re: Geotechnical Response to City Comments
Proposed Residential Development
100 Steacie Drive, Ottawa, Ontario
to: Brigil - James Battison - jamesbattison@brigil.com
date: June 1, 2026
file: PG5788-MEMO.04

Further to your request and authorization, Paterson Group (Paterson) prepared the following memorandum to provide geotechnical responses to city comments regarding the proposed residential development, at the aforementioned site. This memorandum should be read in conjunction with Paterson Group Report PG5788-1 Revision 4, dated December 8, 2026.

PLAN VIEW:

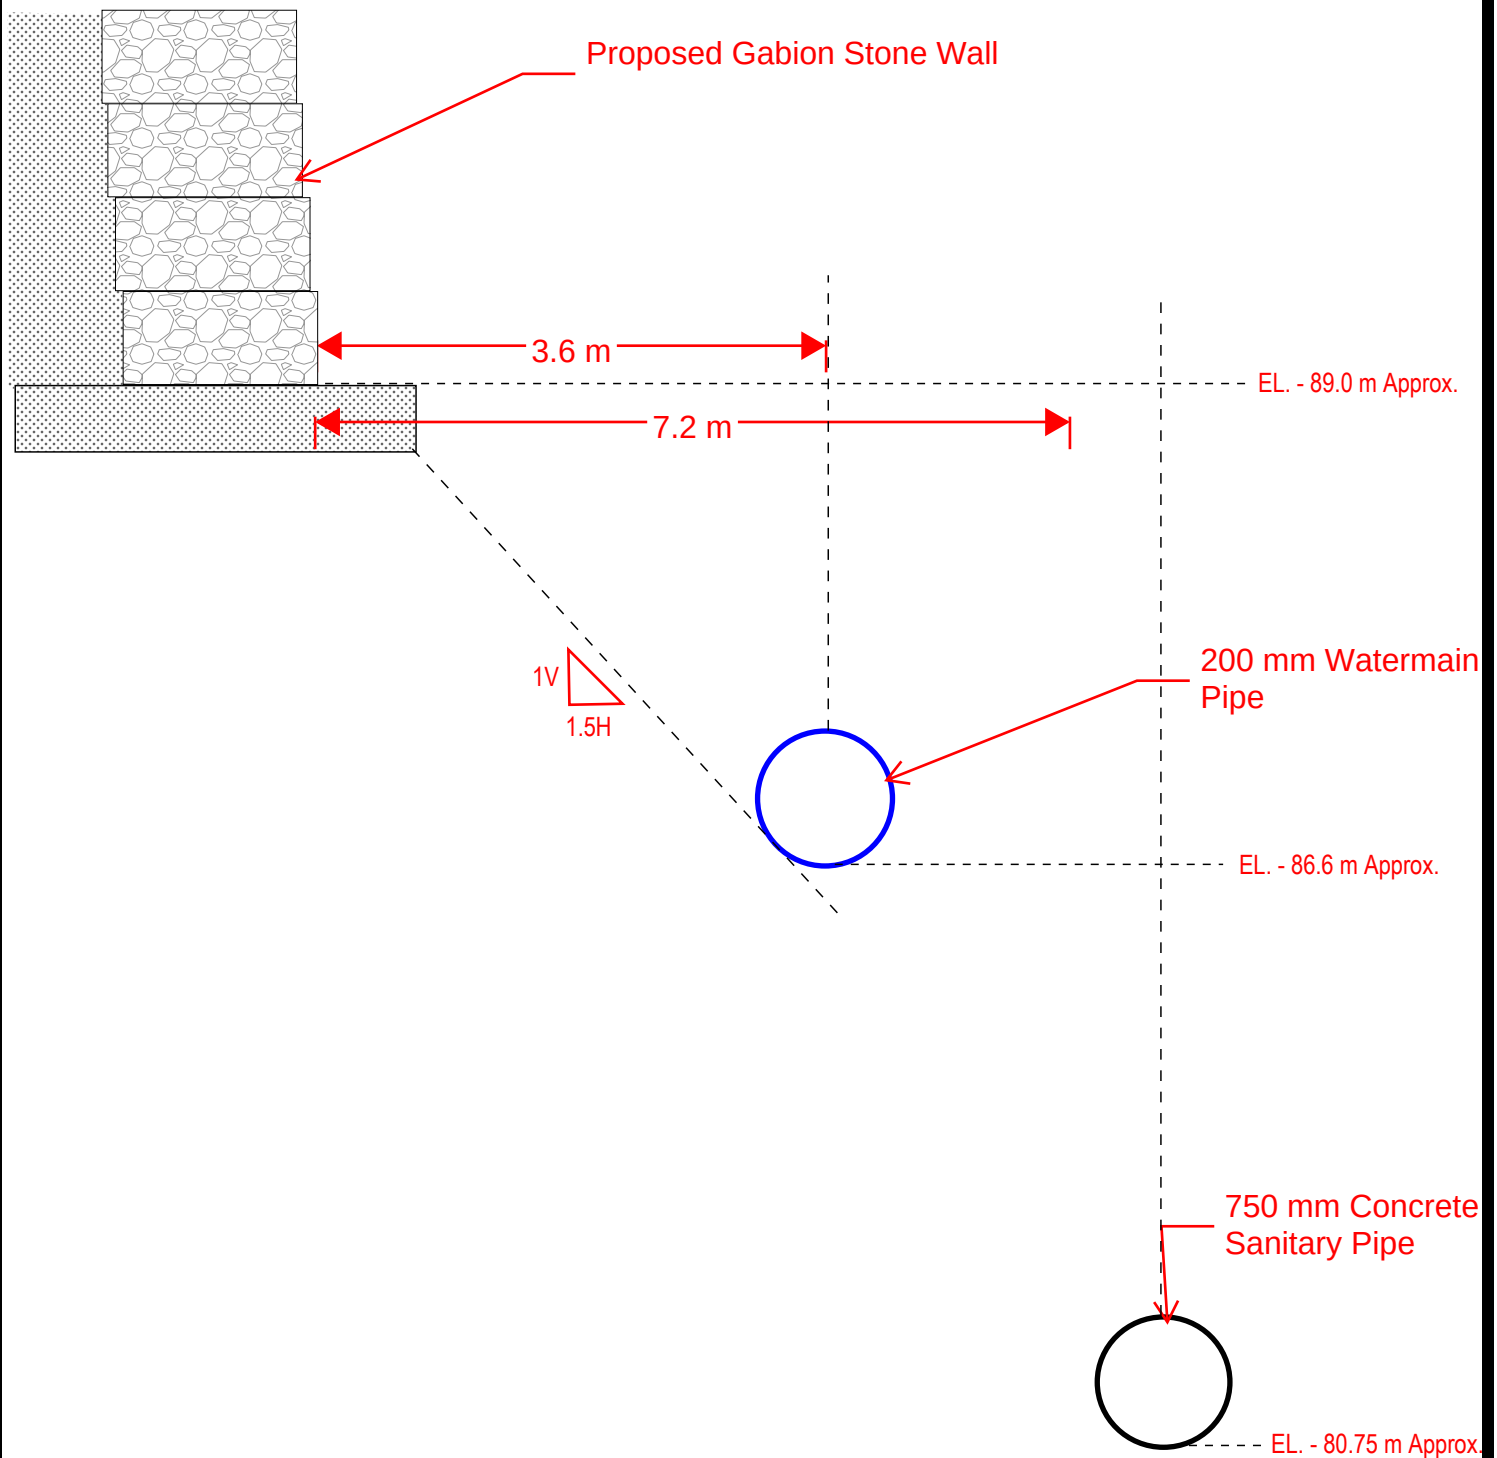
Comment 2: *Section 2.0 must confirm that the new watermain and existing sanitary sewer are located outside the lateral support zone of the proposed retaining wall PG5788-3.*

Response: Based on our review of the site servicing drawing Project No. 160401570 – Drawing No. SSP-1 Revision 8, dated March 24, 2026, the proposed watermain will be located outside the lateral support zone of the retaining wall.

The existing sanitary pipe is located approximately 9 m below the proposed retaining wall. Due to the depth of the existing sanitary service from the bottom of the retaining wall, no loading will be exerted from the retaining wall to the sewer. Furthermore, any maintenance to the deep sewer will require the use of shoring/temporary trenches boxes to be feasible which will further protect the service. Reference should be made to Figure 1 attached below.

- The proposed watermain will be located approximately 2.4 m below the proposed armor stone retaining wall and 3.6 m horizontally setback from the edge of the proposed retaining wall. Therefore, the proposed watermain will be located outside the lateral support zone of the retaining wall.
- Due to the depth of the existing sanitary service from the bottom of the retaining wall, no loading will be exerted from the retaining wall to the sewer.
- A suitable temporary shoring / trench box system will be required for any excavation for the proposed watermain or the existing sanitary pipe in the future.
